Statement by Joseph Campana (Madison Resident) for Diane Kammer (3105 Woods Road, Verona) on Item 13482 – Shady Wood Neighborhood Development Plan

Subject: RE: Draft Shady Wood Plan available for review

Subject: Shady Wood Draft Plan

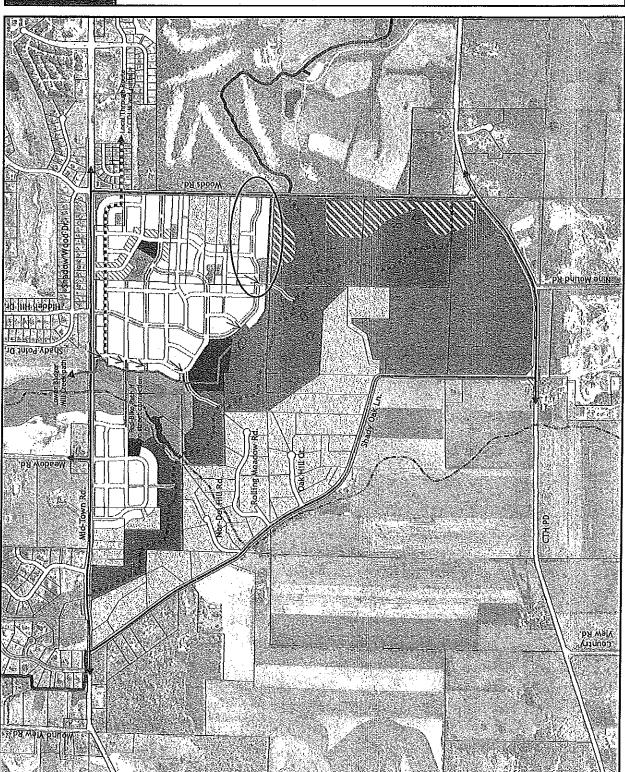
- A. We both support immediate approval to begin the first phase of the plan.
- B. We support the original mapping of the Ice Age Trail, which has been mapped for nearly 20 years. We also support the minor adjustments proposed by the Ice Age Park and Trail Foundation that they have recommended.
- C. We request reconsideration of the recently proposed Ped/Bike Path shown by the red/brown line on the map in the circled area, which designates the Kammer property.

- 1. The neighborhood streets and sidewalks closely parallel the recently proposed ped/bike path.
- 2. The recently proposed bike path parallels city streets.
- 3. There are at least six existing or potential access points, designated by the arrows, between the neighborhood streets and sidewalks and the recently proposed ped/bike path suggesting that portions of, if not the entire, bike path from Woods Road to Midtown Road may not be necessary.
- 4. The Ice Age Trail is another pedestrian corridor that closely parallels the recently proposed bike path.
- 5. The bike path through Ms. Kammer's Property consumes more than one acre of developable property not including the portion of the path that passes through the designed green space at the southwest corner of her property, which consumes an additional acre.

Considering all the physical features of the proposed development Diane Kammer requests that careful consideration be given to either eliminate portions of the recently proposed ped/bike path or to map it south of her property line onto the designated green space, which has already been identified for alternative uses as shown by the hatched area. Alternative use is consistent with mapping the ped/bike path into the hatched area, if the path is necessary at all.
